**PROPOSED AMENDMENT TO THE APPROVED KWU TUNG SOUTH OUTLINE ZONING
PLAN NO. S/NE-KTS/22 FROM "AGRICULTURE" ZONE AND "GREEN BELT" ZONE TO
"GOVERNMENT, INSTITUTION OR COMMUNITY" ZONE AT VARIOUS LOTS IN D.D. 94, 98, &
100 AND ADJOINING GOVERNMENT LAND, KWU TUNG SOUTH, NEW TERRITORIES
(TPB Ref. Y/NE-KTS/18)**

Proposed Amendment to the Approved Kwu Tung South Outline Zoning Plan No. S/NE-KTS/22 From “Agriculture” Zone and “Green Belt” Zone to “Government, Institution or Community” Zone at Various Lots in D.D.94, 98 & 100 and Adjoining Government Land, Kwu Tung South, New Territories (TPB Ref. Y/NE-KTS/18)
Responses to Comments Table

Responses to Comments Table

Design of Drainage System

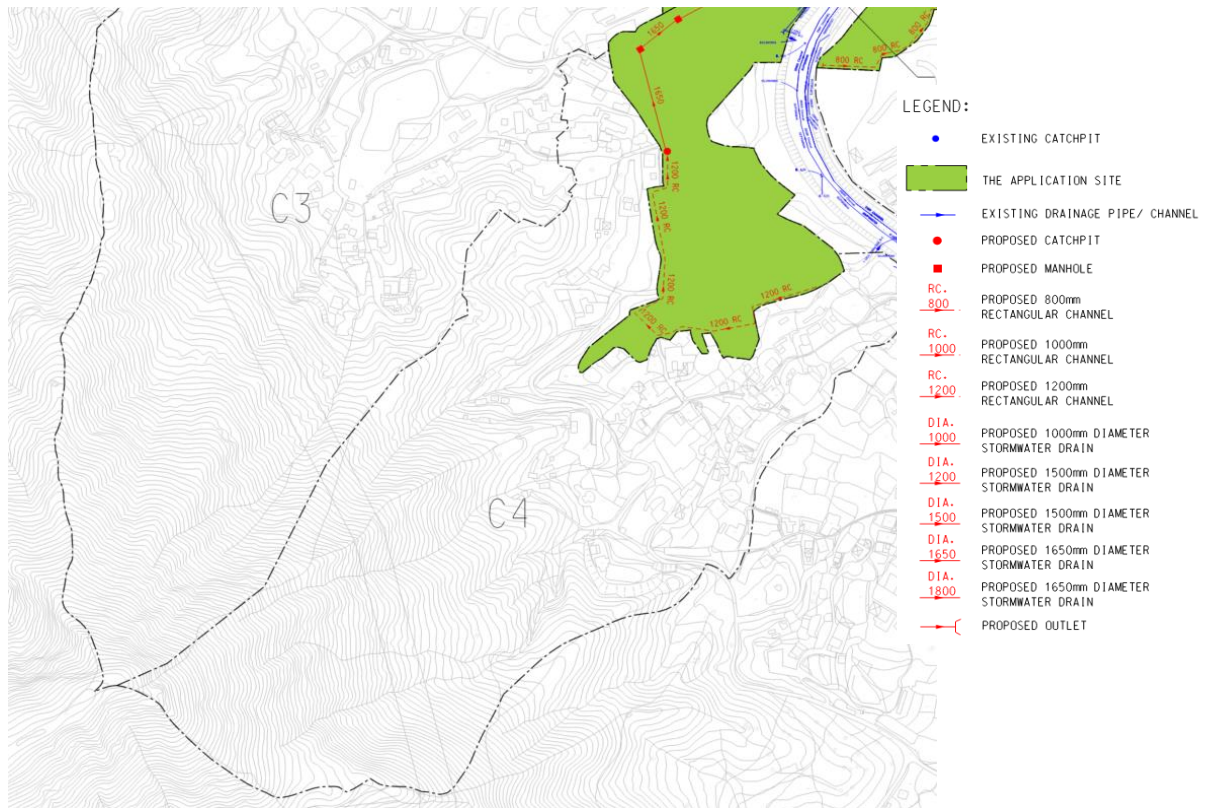
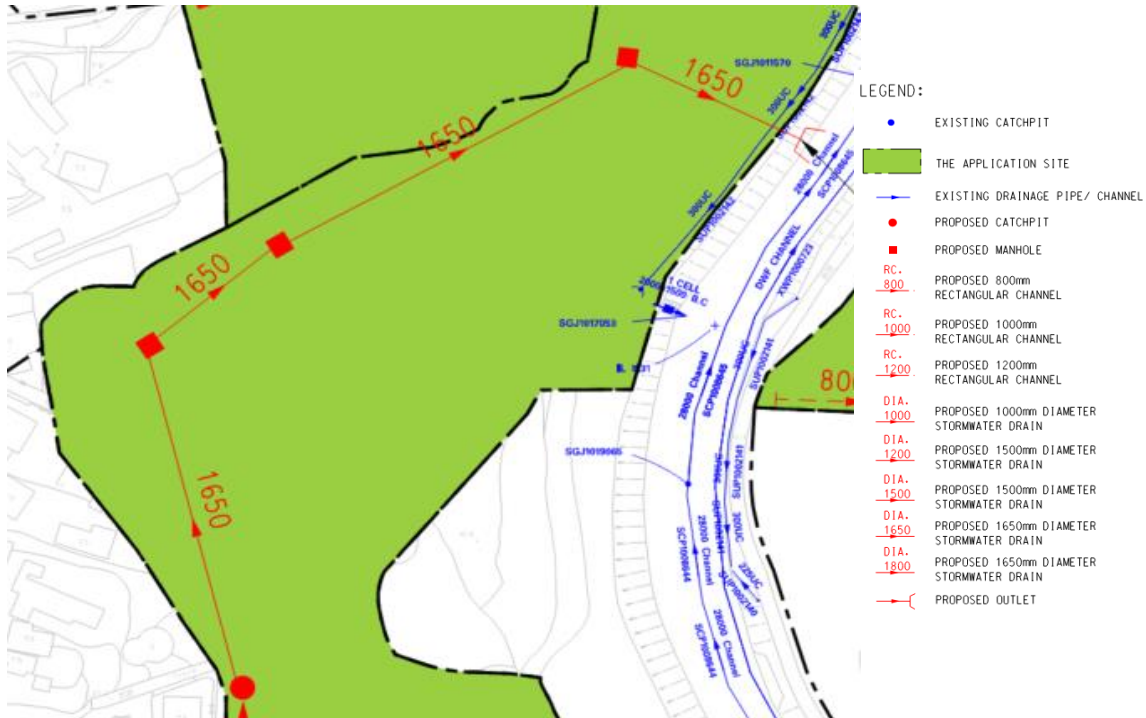
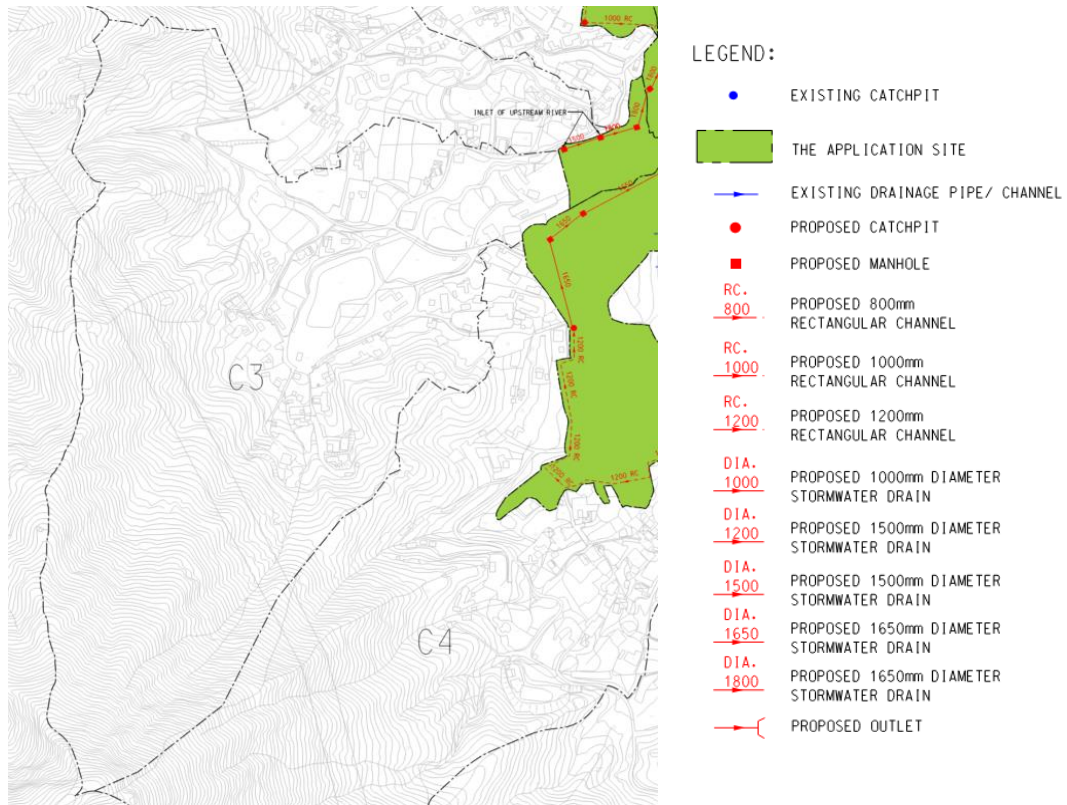
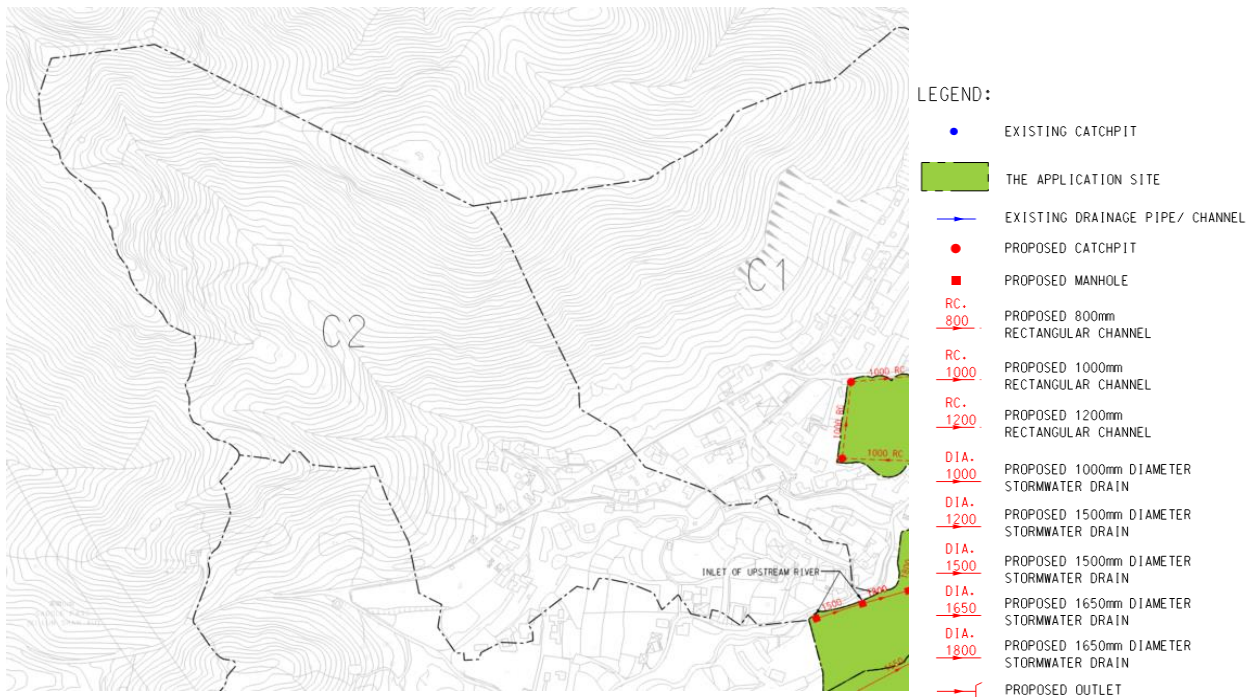
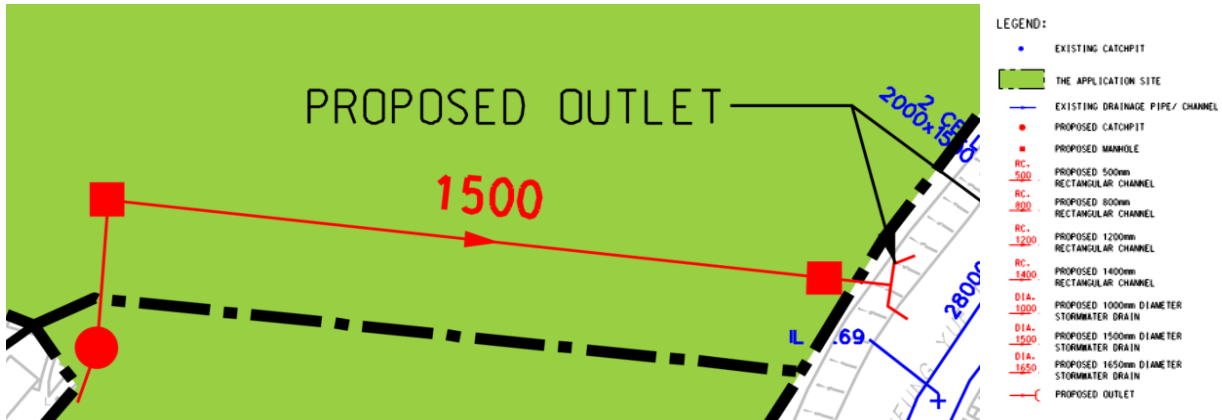
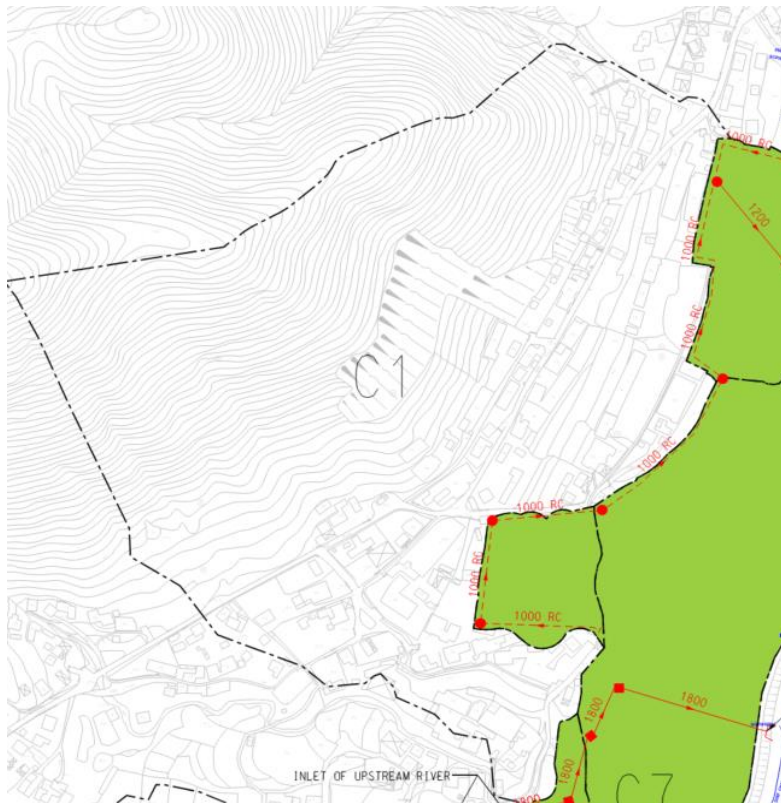
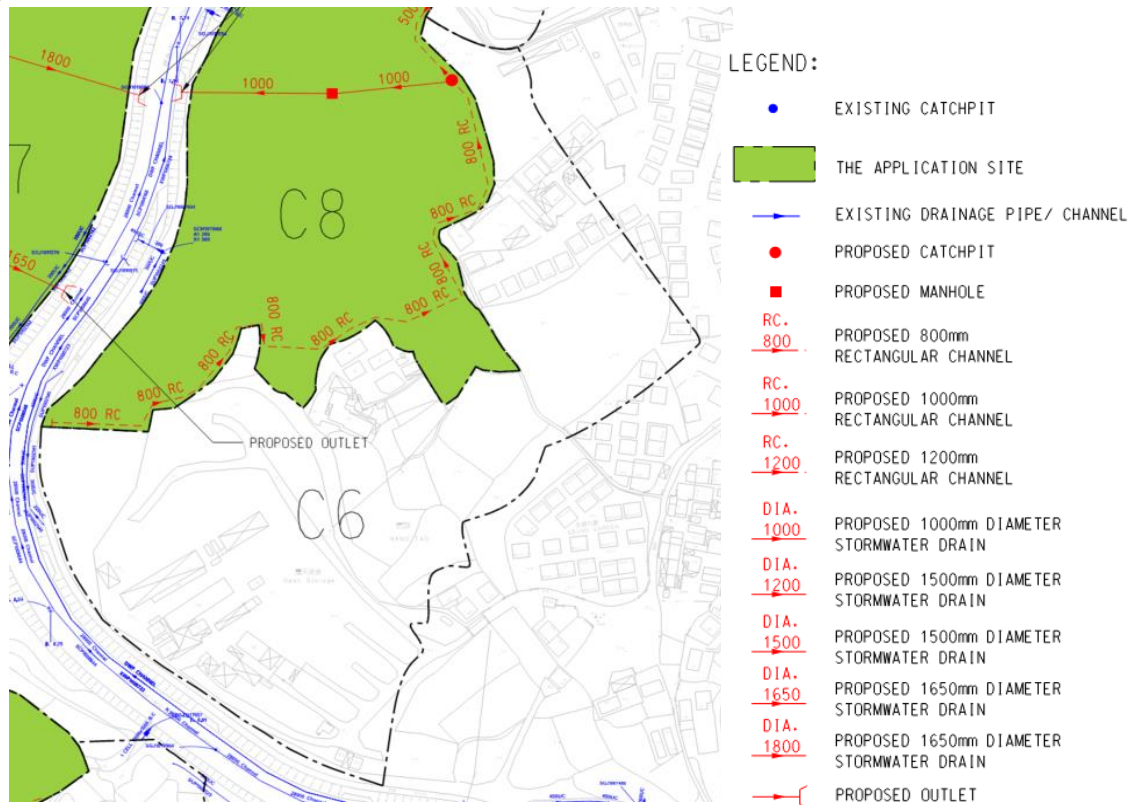
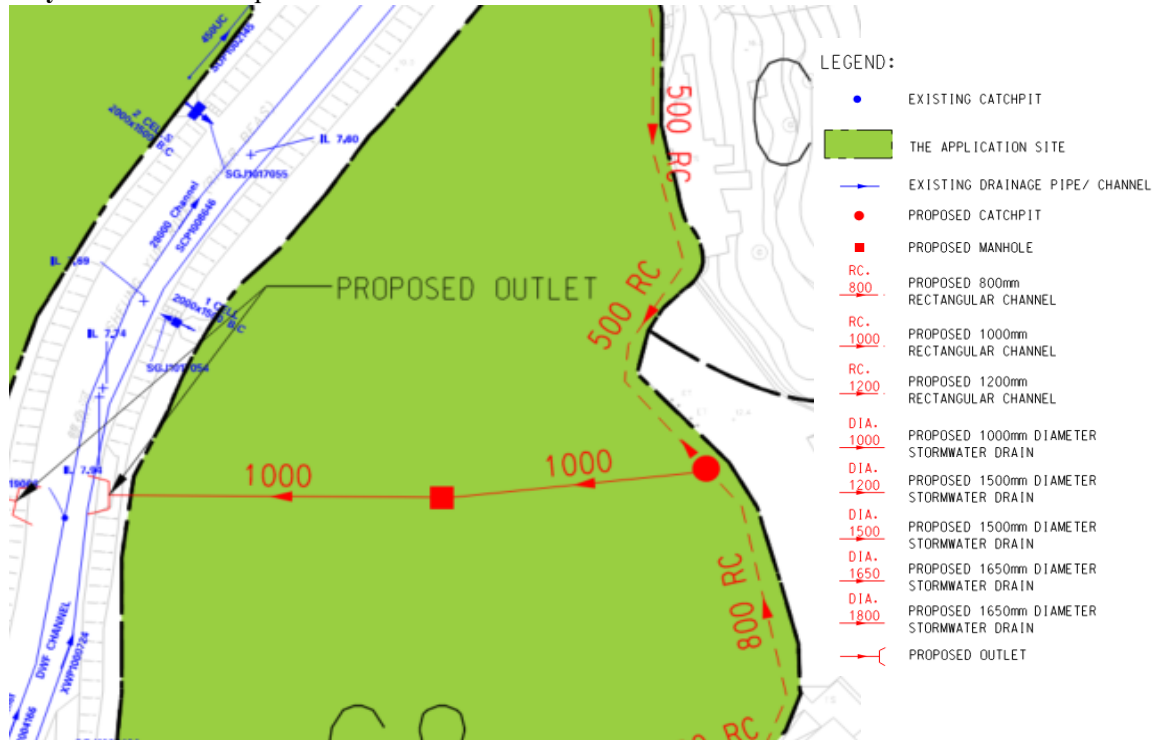
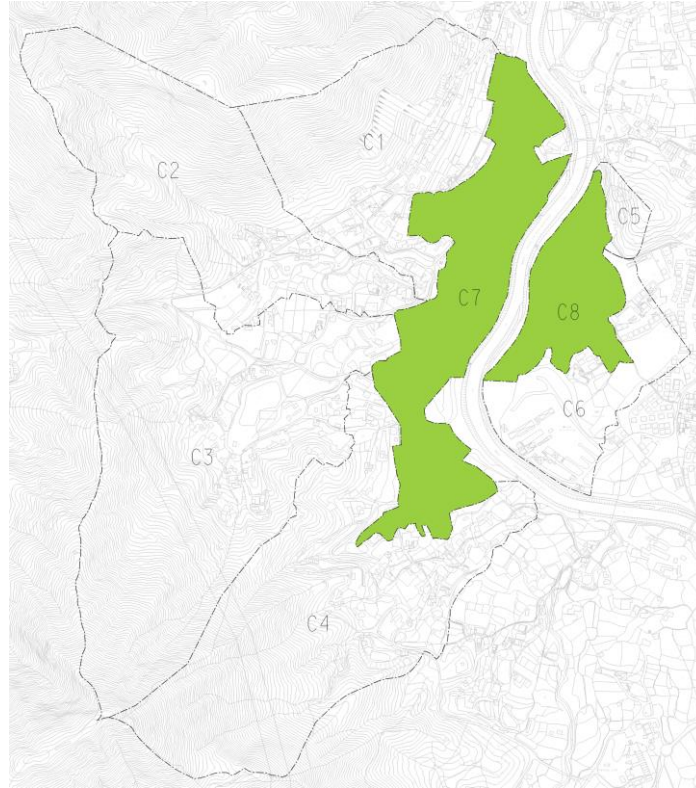
Comments/ Suggestions		Applicant/ Consultant's Responses
3.	Appendix 2 - Please enhance the legibility of the layout plan shown in the capacity check.	Noted. Legends are supplemented to the Annex 3 (Former Annex 2) of the revised DIA (Attachment 3 refers).

Sensitivity Checking of River Beas

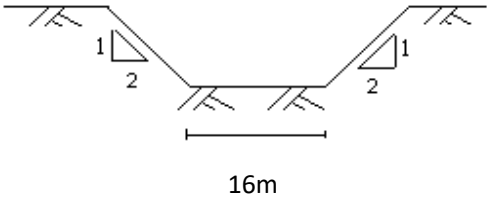
4.	Appendix 2 - Please assess the potential drainage impacts to the River Beas.	Noted. Sensitivity checking of Beas River is provided in the Annex 4 of the revised DIA (Attachment 3 refers).
